ADDENDUM NUMBER THREE (3)

Issuance Date: October 27, 2025

Project Name: Workforce Capacity and Medical Access Project
LaSalle General Hospital
Jena, Louisiana
EDA Number 08-79-05595
Architect Project Number 2024.01

MODEL: 3LBNS4242FB.V2*

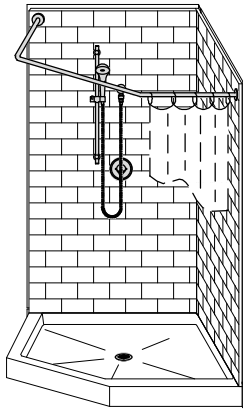
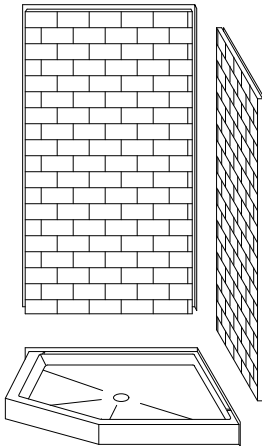
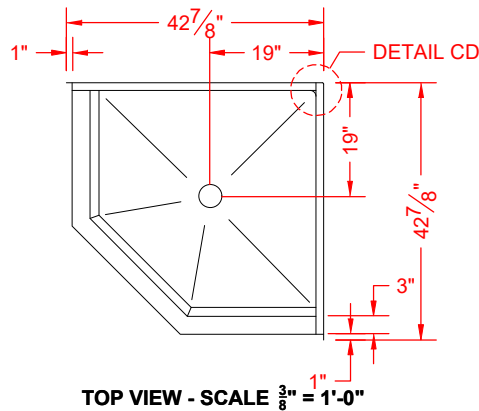
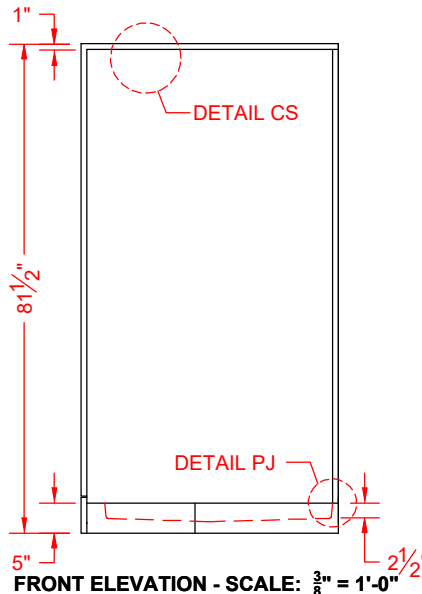
2. Details 32/A5.1 and 33/A5.1 on Drawing A5.1 INTERIOR ELEVATIONS & PLAN DETAILS show the shower module for typical patient restrooms. The basis for design for the shower module is **Bestbath model 3LBNS4242FB.V2_WH** 42"x 42"x 80.5" 3-piece full step in shower with 5" curb, center drain and the following accessories:

- a. ACXRODCRKN4242 – Neo-Angle Corner Curtain Rod Kit for 3LBNS4242 – (1) per RR
 - b. ACXRODHOLD – Rod holder, curtain kit – (1) per RR
 - c. ACXCURT1074 – 100"x 74" heavy duty white vinyl shower curtain. Curtain is staph, mildew, and fungus resistant with weights sewn into the bottom hem. (1) per RR

- d. ACXRINGCLEAR – shower curtain ring, clear plastic – (24) per RR
 - e. ACXSD7SS – 7" wall mounted soap dish – (1) per RR
 - f. ACXDRAIN1000 – 2" no caulk brass drain with polished stainless steel screen for 2" pvc/abs connection – (1) per RR

- g. 076FORM1034 – accessory installation instructions
 - h. 076FORM1051 – multi-piece shower, wood bottom installation instructions
 - i. 074GLUE1047 – construction adhesive white or clear tubes

Demolition Notes (Near Door 100):

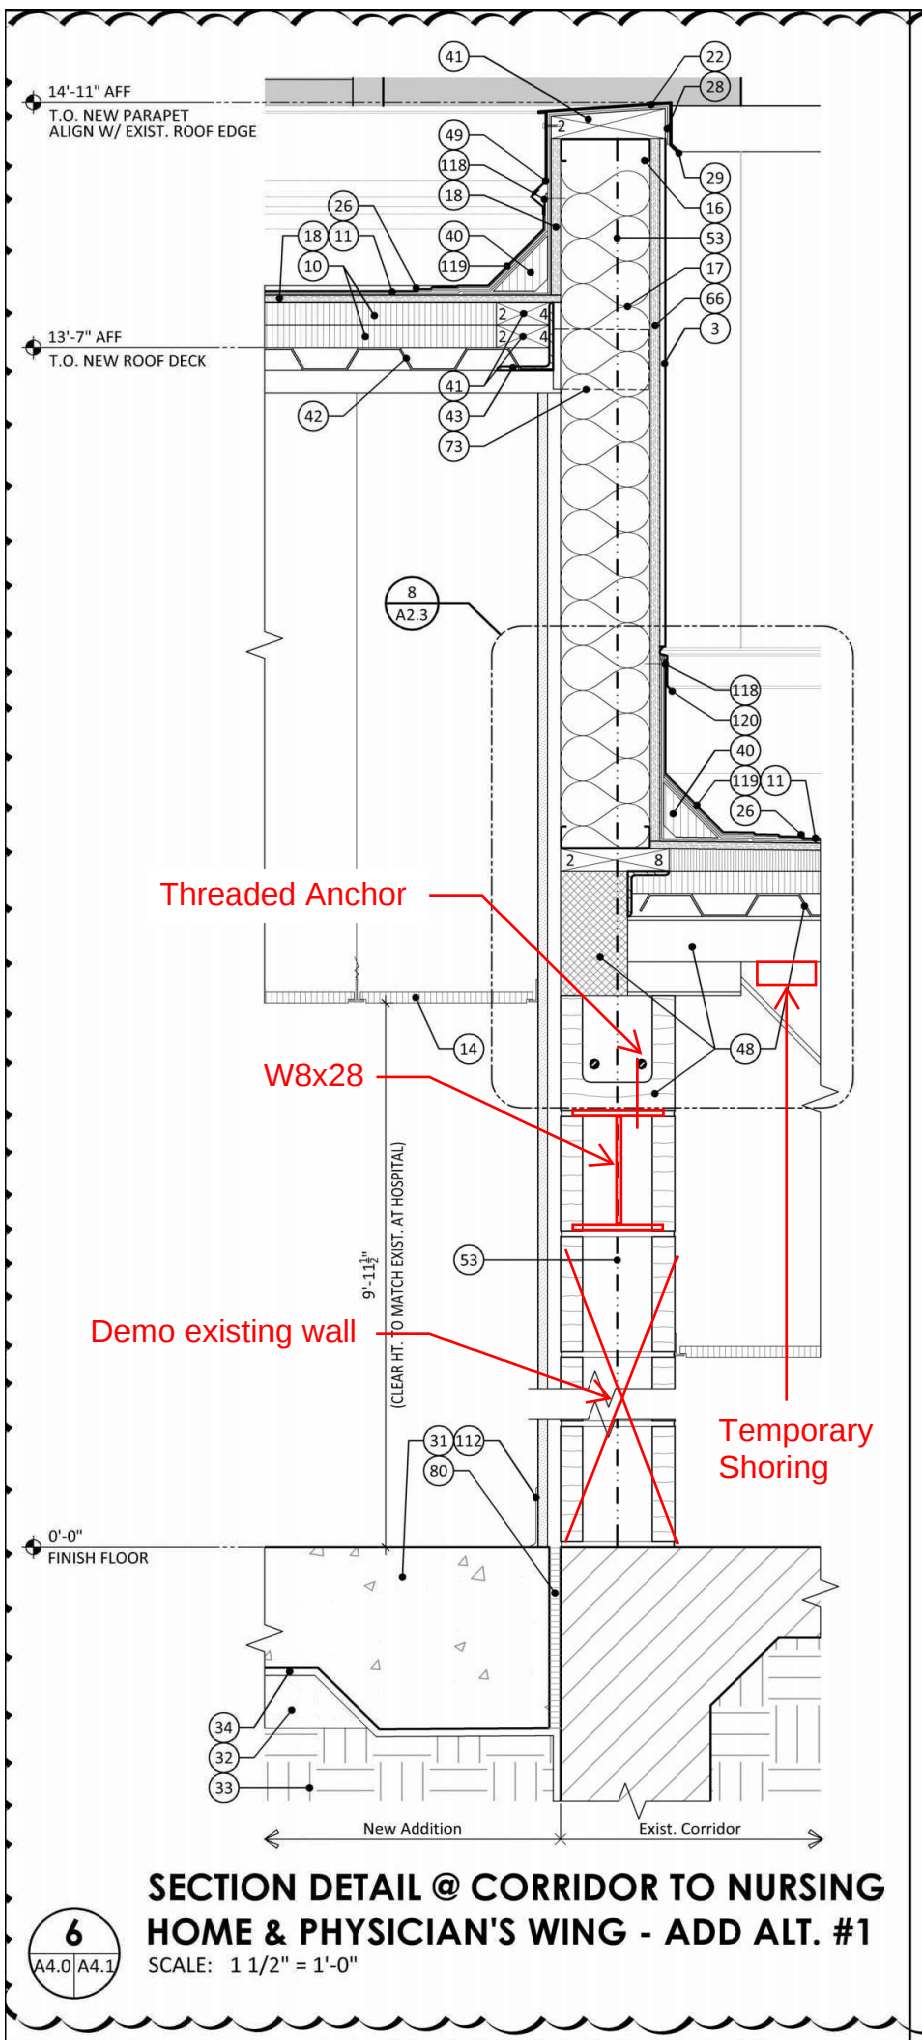
1. Refer to attached demolition detail sketches with notes for partial removal of cmu wall near Door 100 and Door 117 at Physician’s Wing.

1. Install temporary shoring to support existing roof deck. Shoring should be sized to support 1,000 plf.
2. Remove existing CMU wall below existing bond beam (bond beam to remain).
3. Install new W8x28 beam under existing bond beam and connect to existing columns on either side of opening. Use welded AISC Std. Clip Angle connections.
4. Drill and epoxy 3/8" x 4" long A36 threaded rod into existing bond beam at 24" o.c.
5. Once new steel framing is in place, remove temporary shoring.

A2.6

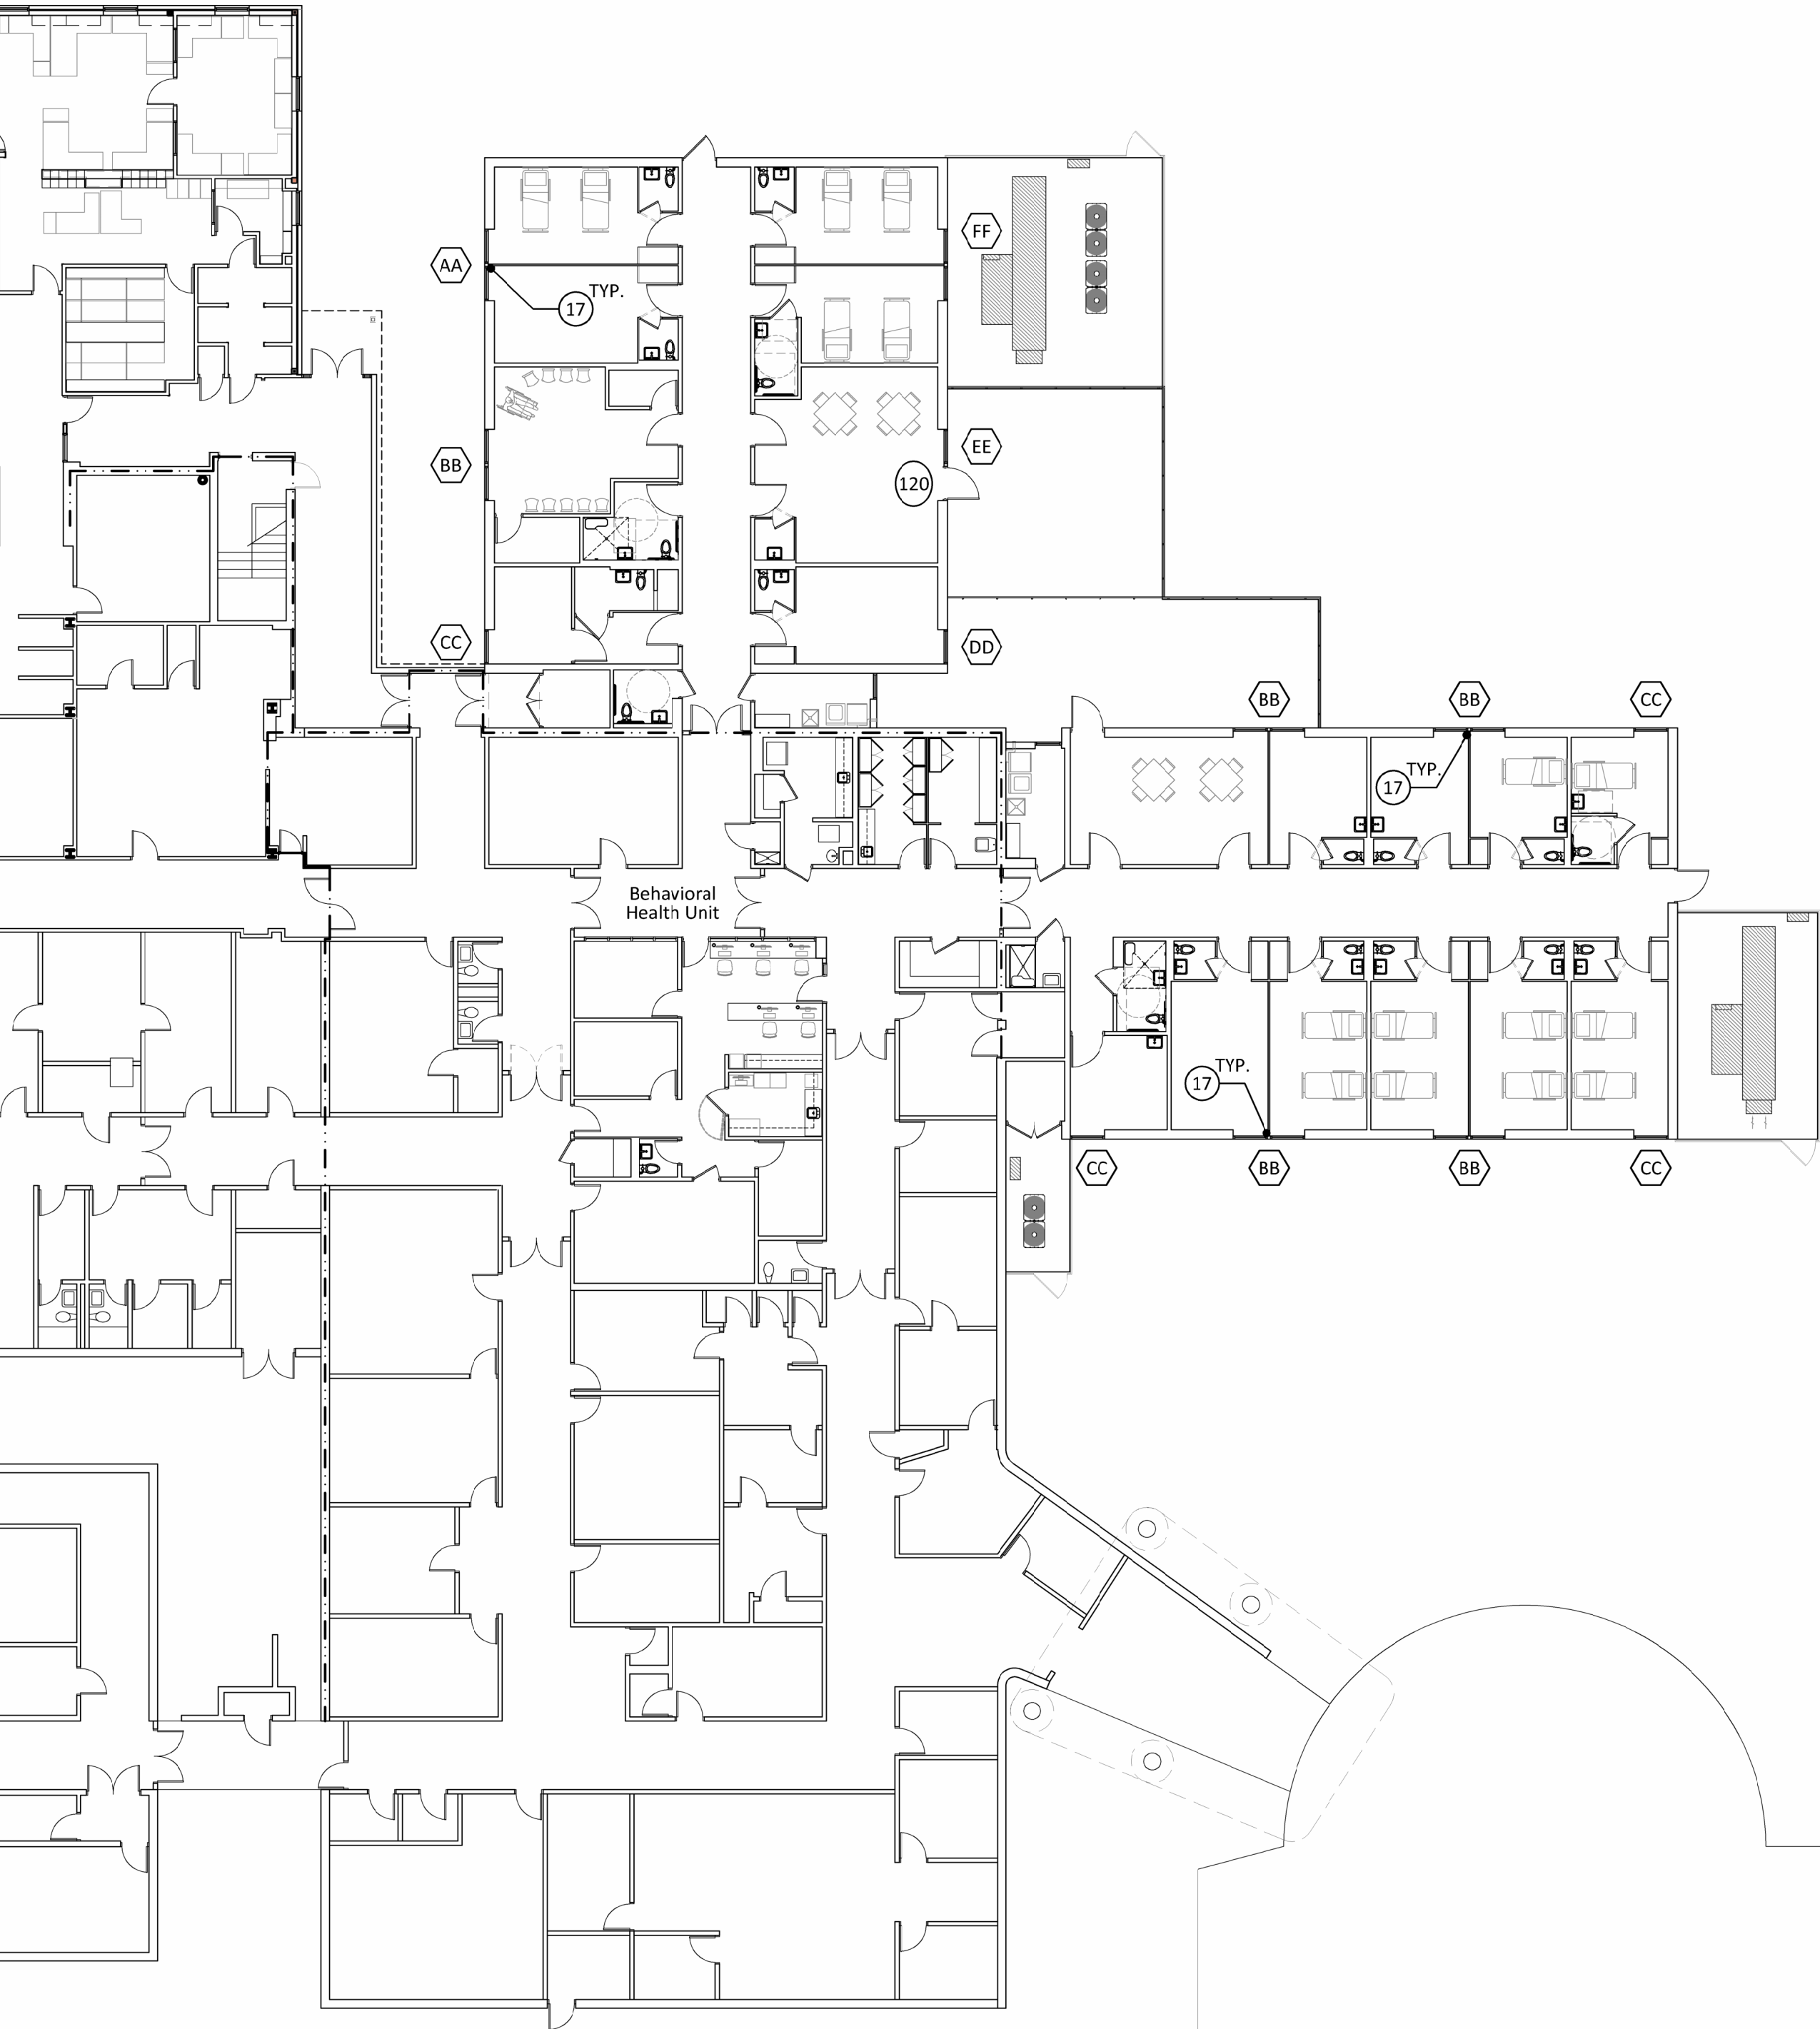
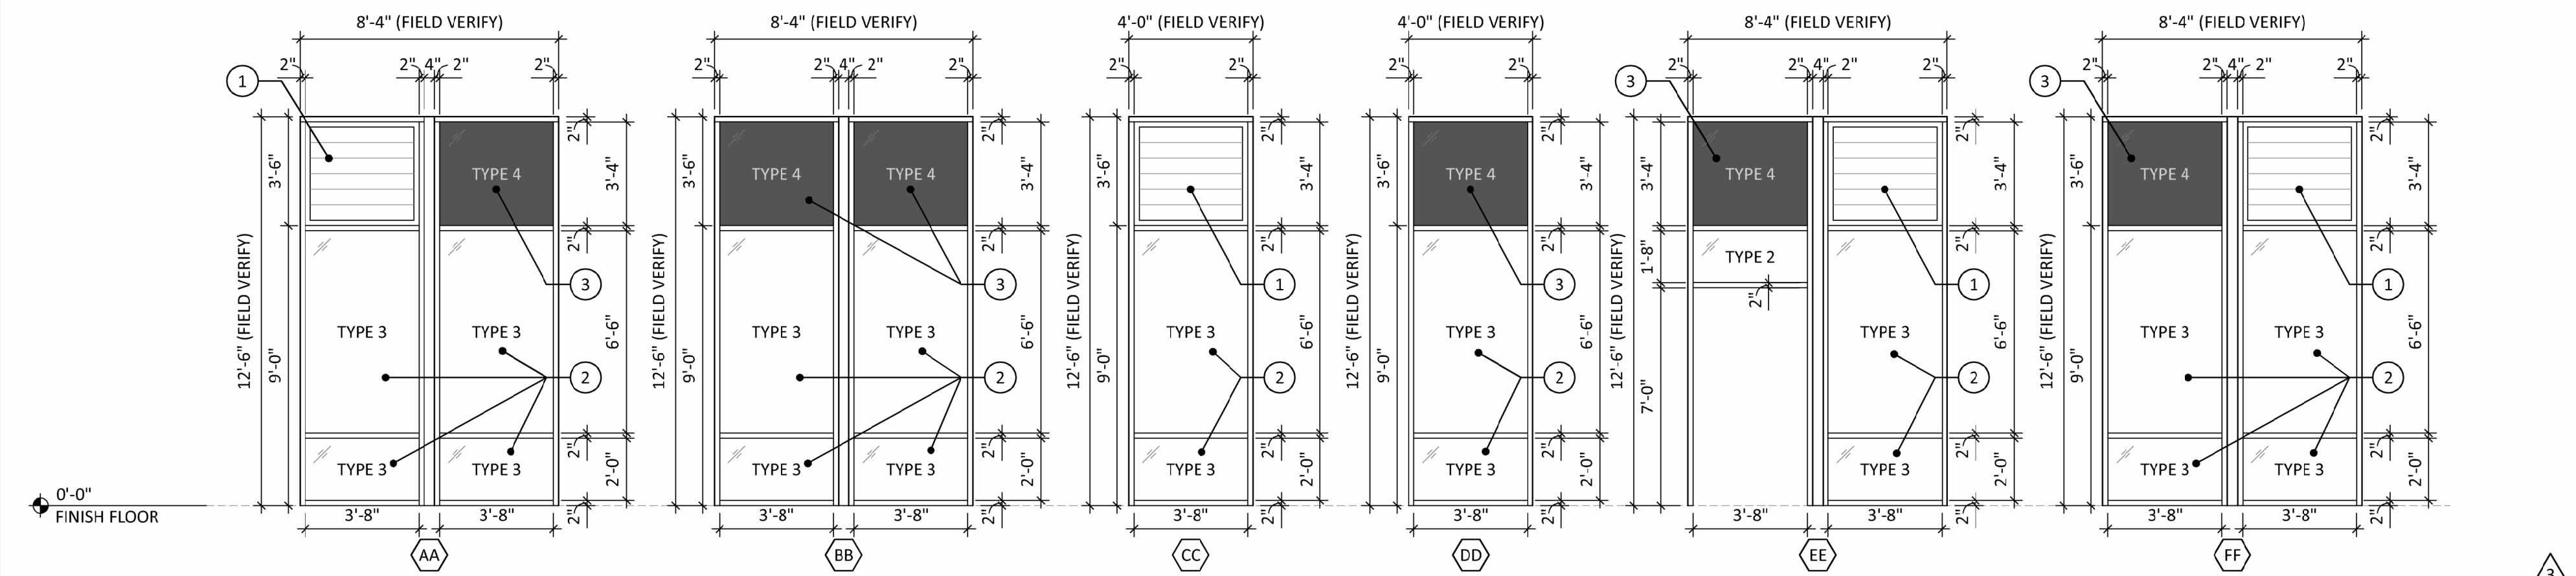
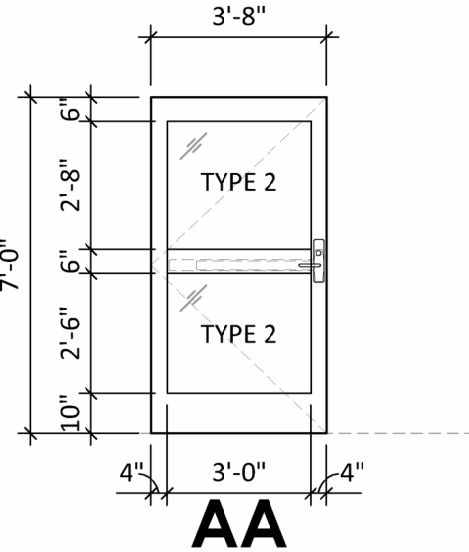
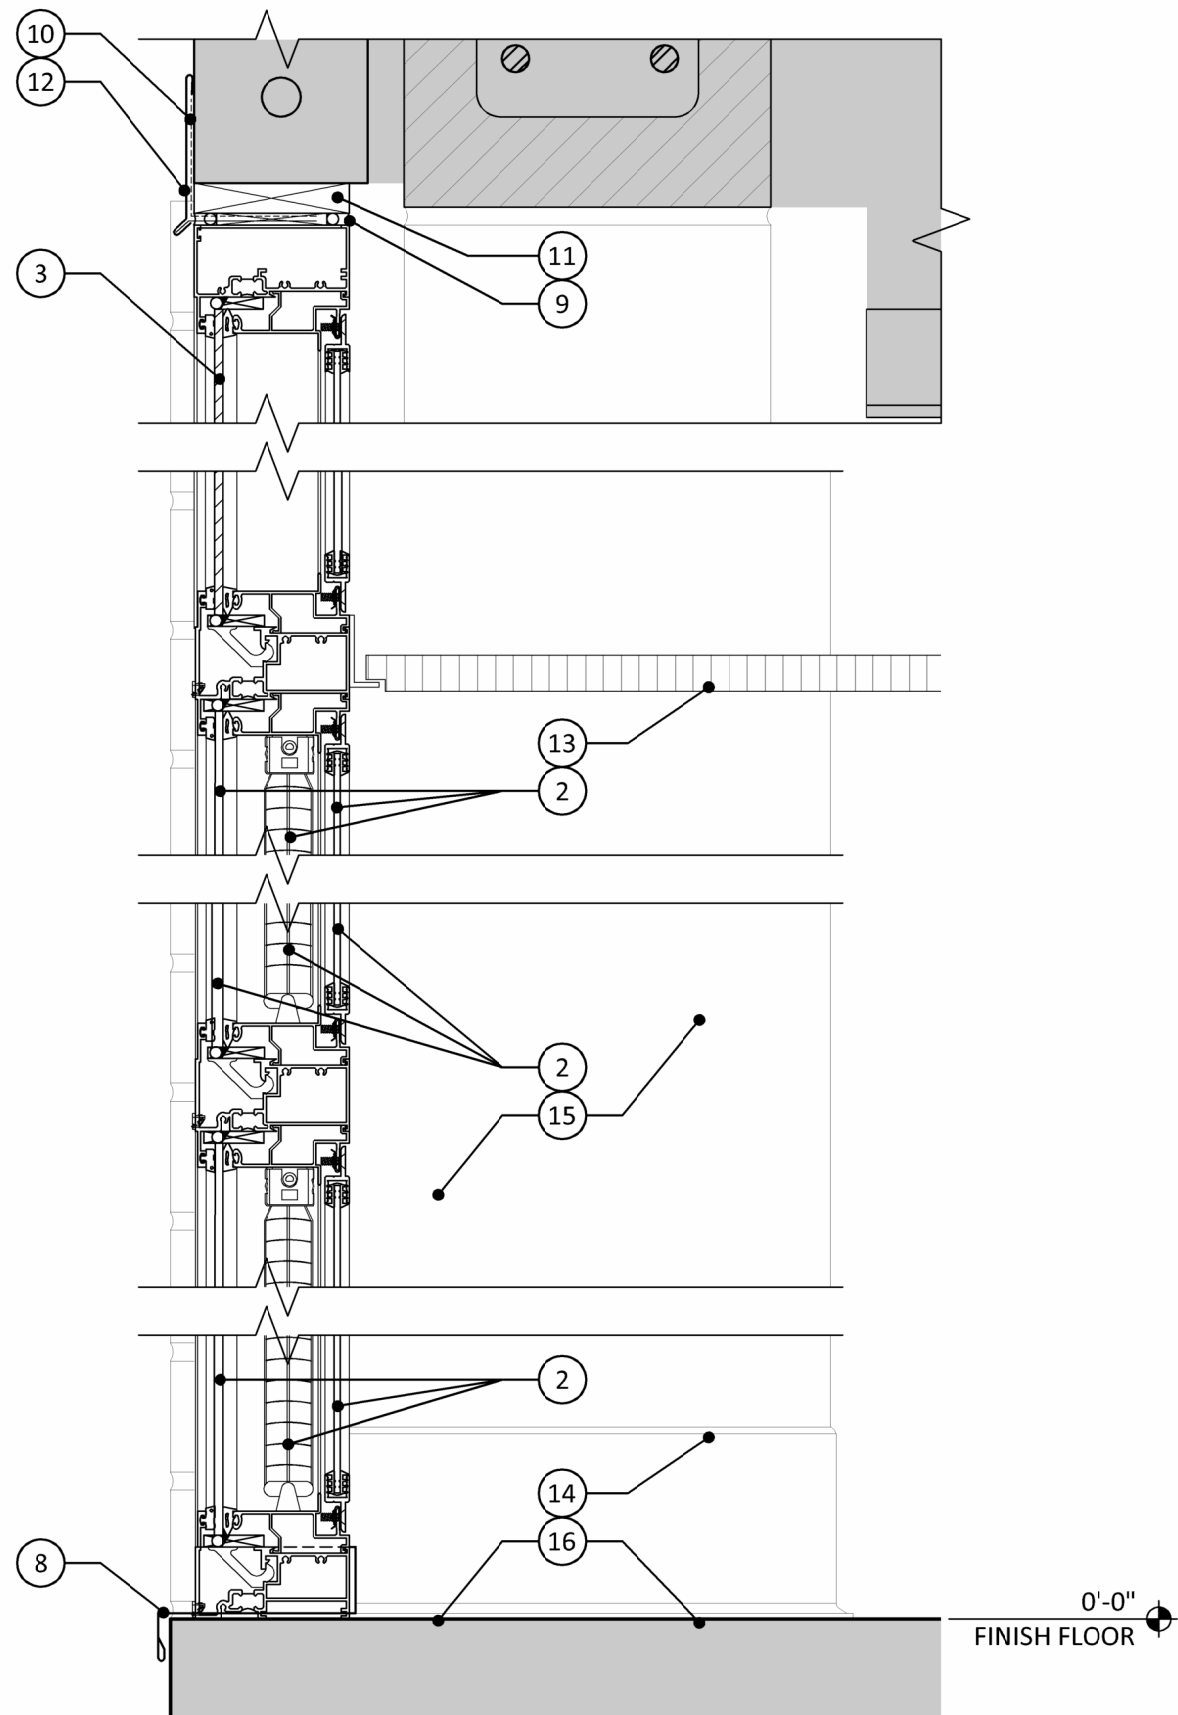
1. Drawing A2.6 ADDITIVE ALTERNATE #2 was intended to be included in Addendum No. One (1) but was left out. That drawing is therefore included in this addendum.

1. Drawing A2.6 ADDITIVE ALTERNATE #2
 - a. Drawing added in its entirety
 - b. Manufacturer List: Products of following manufacturers are acceptable subject to conformance requirements of Drawings, Schedules and Specifications:
 - Kawneer North America – TR-7100
 - YKK AP America – YHS 50 TU
 - Old Castle Building Envelope – Pinnacle Series 66P
 - Substitutions: 01 33 00 SUBMITTAL PROCEDURES – Substitution Request Form
 - c. Aluminum-framed storefront windows shall include the following features:
 - Internal blinds
 - Ligature resistant blinds control hardware
 - Impact resistant glass
2. Drawing A5.0 INTERIOR ELEVATIONS
 - a. INTERIOR ELEVATION KEYNOTES, Keynote 79, **DELETE** “(N.I.C.)” and **ADD** “see SPECIFICATIONS”
3. Drawing A5.1 INTERIOR ELEVATIONS & PLAN DETAILS
 - a. INTERIOR ELEVATION KEYNOTES, Keynote 79, **DELETE** “(N.I.C.)” and **ADD** “see SPECIFICATIONS”
